PUBLIC UTILITIES COMMISSION

Subject: Tule Wind Project - Data Request No. 14

**REVIEW OF NOISE STUDIES AND RELATED MATERIAL
SUBMITTED REGARDING
EAST COUNTY SUBSTATION/TULE WIND/ENERGIA SIERRA JUAREZ GEN-TIE PROJECTS
DATE: MARCH 4, 2011**

Figure 1- Table and Figure D-7 from EPA Levels Document (1973)

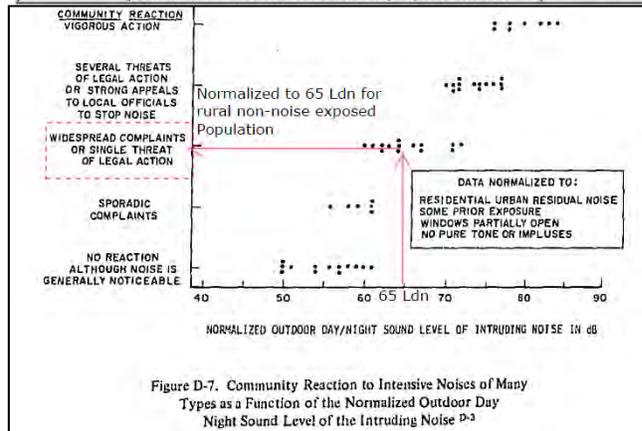
prior noise exposure these levels would not be appropriate. Applying the +10 dB normalizing factor to Figure-7 results in an L_{dn} of 65 dB. Thus, the 45 dBA night and 55 dBA day sound levels that produce little or no negative community response from an urban/suburban population with prior noise exposure will result in widespread complaints and threats of legal action if they are experienced in a rural community. To avoid complaints the rural community L_{dn} must not exceed 45 dBA during the day and 35 dBA at night. If the rural community had no prior experience with noise exposure then an additional 5 dB is added to the normalization process. This would result in a nighttime limit of 30 dBA and a daytime limit of 40 dBA to avoid complaints.

Figure 2- Example of wind shear in neutral and stable atmospheres

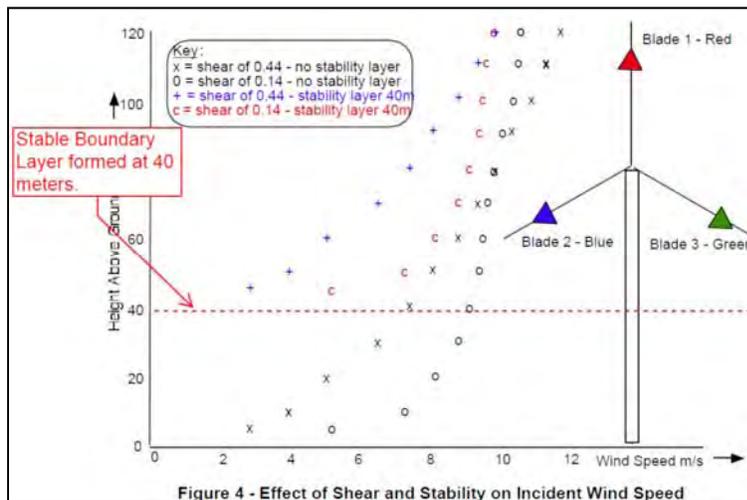
IEC 61400-Part 11: acoustic noise measurement techniques: The purpose of this standard is to provide a uniform methodology that will ensure consistency and accuracy in the measurement and analysis of acoustical emissions by wind turbine generator systems. The standard was prepared for application to wind turbine manufacturers trying to meet well-defined acoustical emission performance requirements, and the purchaser in specifying such requirements. This standard is used to determine the sound power level emitted by wind turbines under conditions defined as normal operation. Normal operation is specified as weather conditions that are not severe and represent operation with low wind shear. Such conditions are normally defined as a "neutral" or "unstable"

atmosphere where the windshear will generally be in the range of 0.15 or less and in general under 0.20. This weather condition is commonly observed during daytime of warm seasons and in particular can be described as a warm sunny afternoon in the temperate zone. Under low wind shear conditions the wind speed does not increase significantly between the height where the blade is lowest in this rotation and the top where it is at its highest peak. This allows the anemometer located on the turbine's hub to calculate the optimum angle of attack of the blades and RPM of the hub for maximum efficiency in extracting energy. Because inefficiency in extracting energy results in increased noise, heat, turbulence, and additional stresses on the blades the lowest noise immission condition for wind turbine is when it is most efficiently extracting energy from the wind. In a paper by William Palmer, P.ENG., Ontario Canada the effect of varying wind shears on wind turbine noise is explored⁷. Figure 2 shows an example of the optimal weather conditions for a windshear of 0.14 with no stability layer (temperature inversion boundary). The second best situation is a higher-level windshear such as 0.44 again without a stable boundary layer. However, because there will be a significant difference in the wind speed at the bottom and at the top of the blades rotation path the windshear of 0.44 will be more difficult for the turbine to find the optimum operating mode then for the 0.14 windshear. Both of these conditions follows a logarithmic relationship described as the Power Law which permits the estimation of a wind speed at some arbitrary height such as the hub from the wind speed at a lower height such as a 10 m meteorological tower.

Figure 3-37 Leq just meets the 45 CNEL criteria

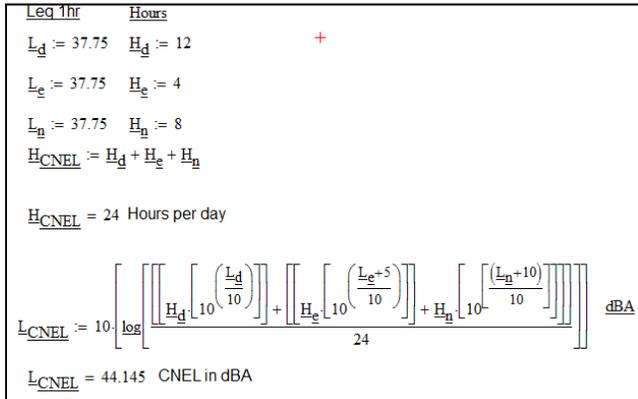
the model had correctly addressed tolerances and the need to increase the IEC61400-11 sound power levels to account for increased sound emissions at night the contour map and tables would be at least eight (8) dBA higher. This increase would have expanded the boundary of the 40 dBA

threshold to include many of the homes around the perimeter of the Project. As a rule of thumb, assuming that the increased sound power for nighttime operation results in a 5 dBA increase and the 3 dB ISO tolerances are included, all receiving properties that have sound level projections between 32 and 40 dBA will exceed 40 dBA.

Figure 5-Vestas V-52 Spectrum (From NREL)

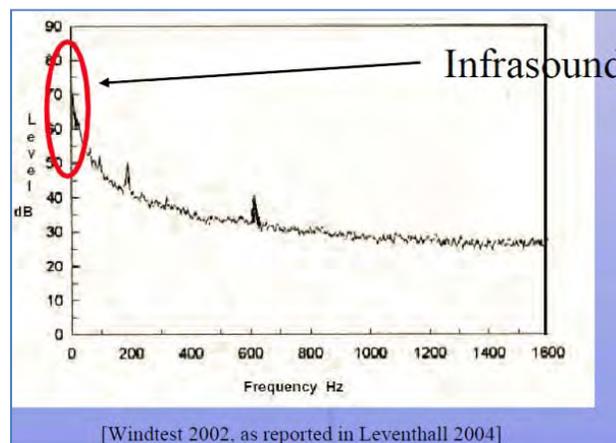
In Figure 5, the wind turbine spectrum for a Vestas V-52 shows some of the same spectral characteristics. It does not show the tones and harmonics at the blade passage frequency (BPF) because for industrial scale upwind turbines this is usually between 1 and 2 Hz and the harmonics occur below 10 Hz. Because this is a difficult range of frequencies to measure, especially in field test situations, most information about the spectral characteristics do not show the infrasound range (0-20Hz) sound pressure levels (SPL). This is further obscured by the practice of wind industry acoustical consultants to present data using of A-weighting (dBA). The practice masks the spectrum shape by creating a visual impression of minimal low-frequency sound content. Even when octave band (1/1 or 1/3) SPLs are presented the reports normally ignore frequencies below 31.5 or 63 Hz. The wind industry and its consultants often conclude that there is little or no infra or low frequency

Figure 6-Wind Turbine Infrasound
the Infrasound work shop in 2005 (Tahiti).

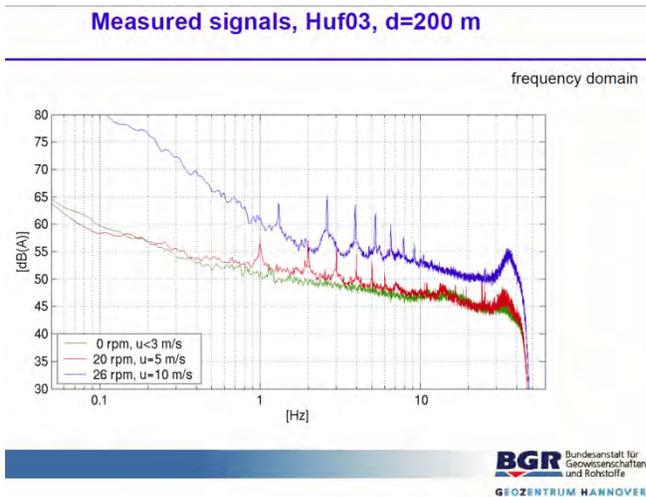
The graphic to the left (Figure 6) is expanded in the lower frequency range to show a wind turbine's spectrum for the frequency range of 0-10 Hz. Now the tones and harmonics are clearer. Also, note the correlation of the frequency of the tones to rotational speed. This graph is from a study conducted by the Federal Institute for Geosciences and Natural

Figure 9-Audible Blade Swish inside home from New York Wind Utility

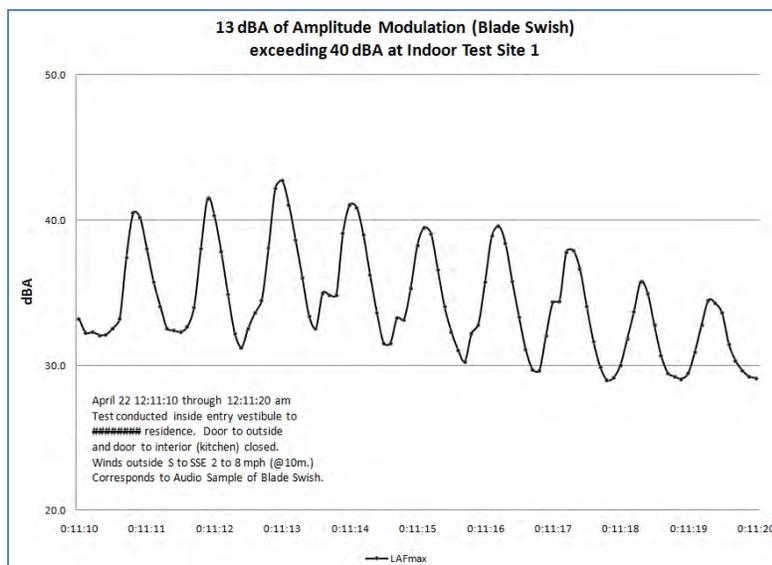
This author has confirmed night time amplitude modulation (blade thumping) at every wind project he has investigated. During periods of high turbulence or wind shear levels the sound levels produced by blade "thump" have been as high as 10-13 dBA. Figure 9's graph shows the rise and fall of the A-weighted sound levels from blade swish measured inside a closed entry vestibule to a home. This test site is approximately 1500 feet from two (2) turbines with sound emission characteristics similar to the turbines proposed for the Project. It should be noted that other tests measured sound levels exceeding 40 dBA inside the home in the rooms facing the turbines with a window

Figure 10-Annoyance inside a home for outside wind turbine noise.

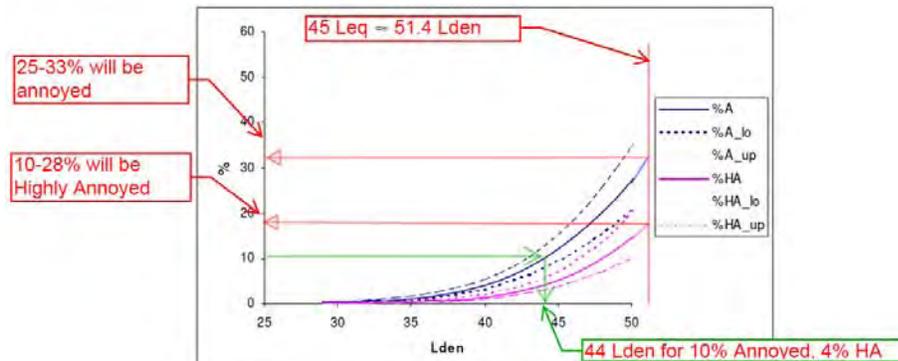
A recent paper by Drs. Pedersen and van den Berg assessed the annoyance felt by people inside their homes for various sound levels of wind turbine noise outside the homes. Figure 10 shows the annoyance level for the situation of 45 Leq outside the home. This results in an annoyance value of about 1 out of every 3 people. The position that 45 dBA wind turbine noise outside a home is compatible with sleeping inside the home (even with the windows closed) is shown to be false.
